## **CABINET MEMBER FOR ENVIRONMENT – 13 FEBRUARY 2020**

### **OXFORD – ACCESS TO HEADINGTON: FURTHER CONSULTATION ON TRAFFIC MEASURES**

**Report by Interim Director Community Operations**

## CycloX response to Access to Headington - Cherwell Drive & Headley Way (Oxford) Proposed Side Road Entry Treatments

a) Elms Drive – approximately 7.9m long and 6m wide

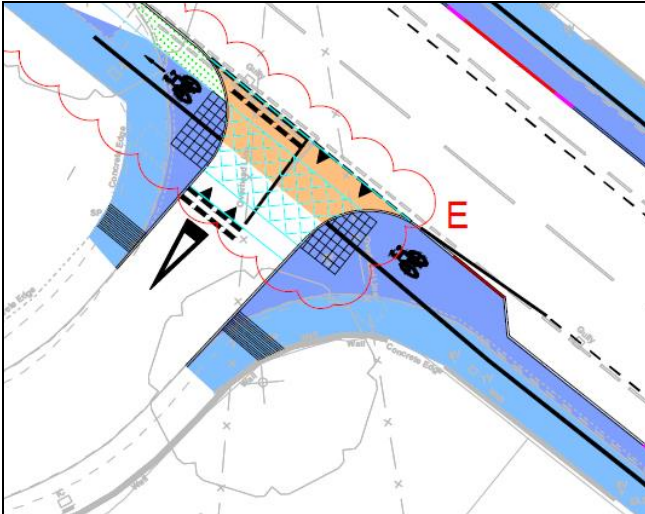
Despite the reduced radii, this junction is compromised and unacceptable without the ramp shown in the drawing as the radii are still too generous for a quiet residential road.

We welcome the effort to maintain a level and continuous footpath and cycleway. However, Cyclox would urge the council to change the material to reflect the continuity of the new cycle-path. The current edge to the vehicle path, provided by the buff anti-skid surface, reduces the 'pavement-ness' of the crossing. It needs to be extended to provide the visual cue that the footway and cyclepath are continuous, have priority, and to help solve the encroachment issues.

The material used needs to continue unbroken and well beyond the junction with no materials or structures indicating the edge of the space to be used by vehicles. It needs to be the same height as the footway in relation to the road with no kerbs or kerb-like structures to highlight the line to be taken by vehicles. Ideally the end of the side road should narrow to one car width to highlight this feature as vehicles approach the main road.

The Dutch have perfected this and the Dutch Entrance kerb is now available to use for this situation from Aggregate Industries. ([www.aggregate.com/products-and-services/commercial-landscaping/kerbs/dutch-kerb](http://www.aggregate.com/products-and-services/commercial-landscaping/kerbs/dutch-kerb))

a) Snowdon Mede – approximately 6.9m long and 3.4m wide

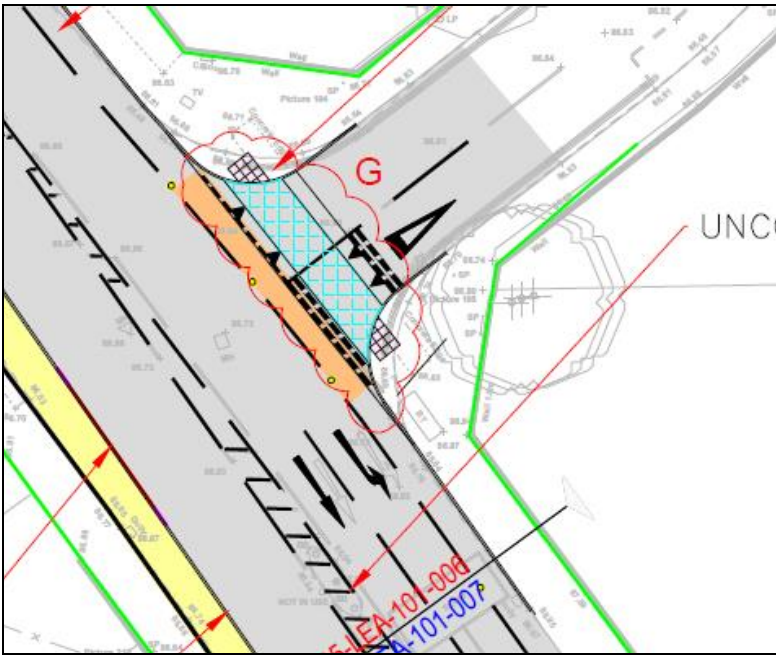
We would like to see the footway and cyclepath continuous in both level and material to reinforce the continuity of the pavement, with the absence of any kerb-like vehicle path indicator. This would enable a safer crossing for both pedestrians and cyclists alike.

c) Cope Lane – approximately 8m long and 6.4m wide

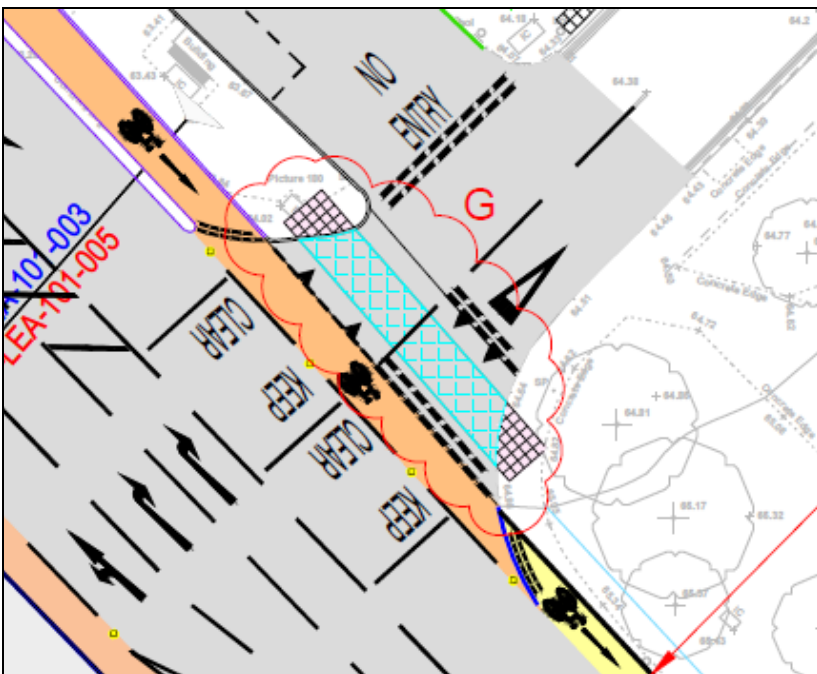
The cycle give-way line markings are not acceptable, they provide a vehicle edge and undermine what is the most promising aspect about this junction – its full segregation in space and time. A cyclist having cleared the major junction then has to look both behind and forwards simultaneously and then possibly yield whilst essentially being on the main carriageway, even if travelling less quickly than motorised traffic. This is a major impediment to continuity and effectively creates an unacceptable 'dual network' (a concept which is to be removed from the provisions in the

forthcoming replacement for LTN2/08<sup>1</sup>) and negates any advantage of the segregation. This junction is not coherently designed and it should have the same cycle priority as the junction at Eden Drive. As can be seen below, the table is needed to stop cars using the cyclepath as the give way.

d) Cholesbury Grange – approximately 5.3m long and 3.1m wide.

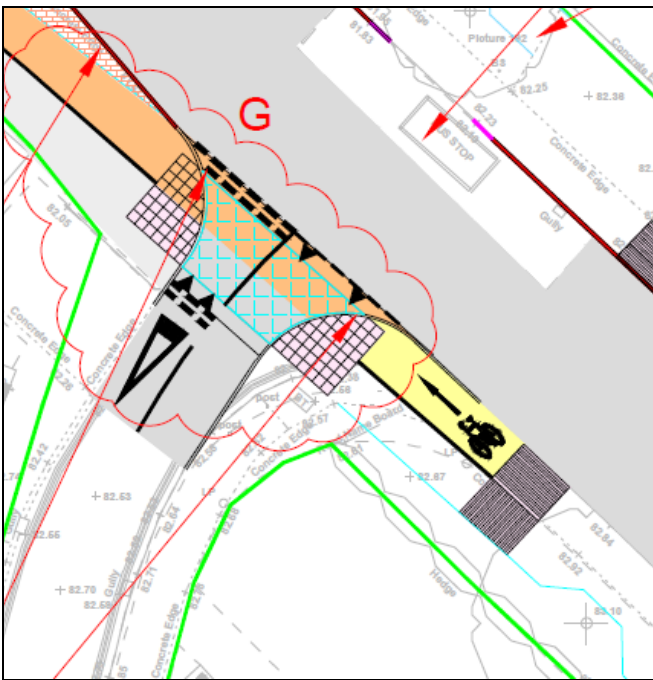
We would like to see the footway and cyclepath continuous in both level and material to reinforce the pavement, with no vehicle edge provided by the kerb-line.

The kerb-line indicates to drivers ‘their space’, which is counter to the priority proposed for cycling and walking.

This would enable a safer crossing for both pedestrians and cyclists alike.

3. Oxford Road – from a point 15 metres southwest of its junction with Cherwell Drive continuing southwest until outside 46 Oxford Road for a distance of approximately 16 metres.

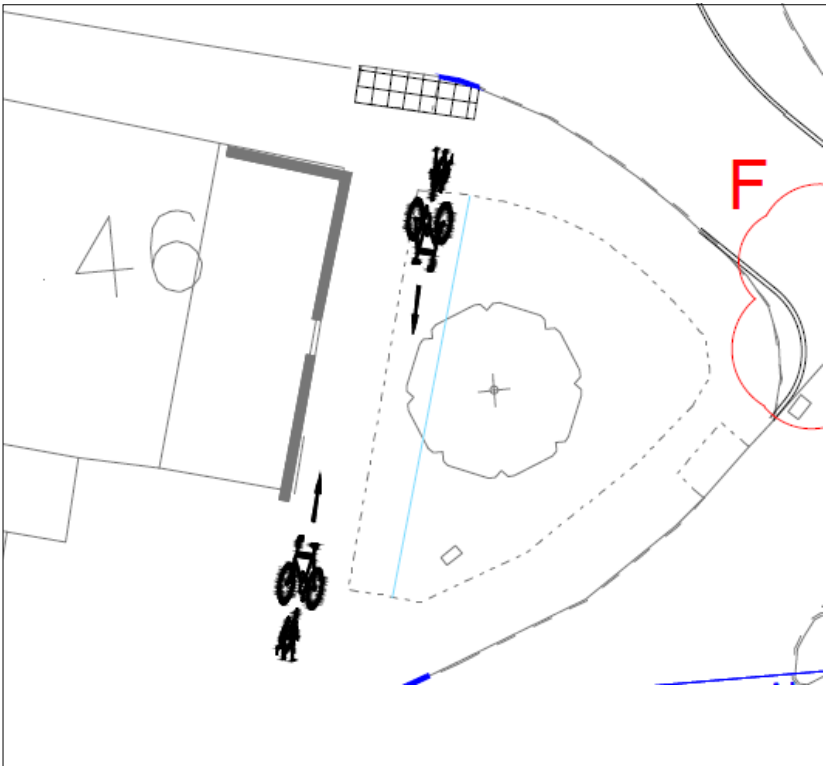
This is a welcome intervention to prevent further disputes and maintain the continuity of footpaths and cyclepaths. We object to the incursion of the 'Transition Kerb' over the alignment of the shared-path area – approximate location indicated by the blue-circle above. We also object to the DYs that run across the dropped kerb incorrectly

15. In response to the above, the detailing of side road entry treatments is agreed to be a very important matter and one that does require further consideration as part of a wider review of the design of measures to support sustainable transport. However, it should also be noted that the currently proposed layouts have been widely used in Oxford with typically good levels of public acceptance and also with very good levels of safety. The detailed design will, however, be reviewed to address the concerns raised over the detailing of the shared use cycle track.
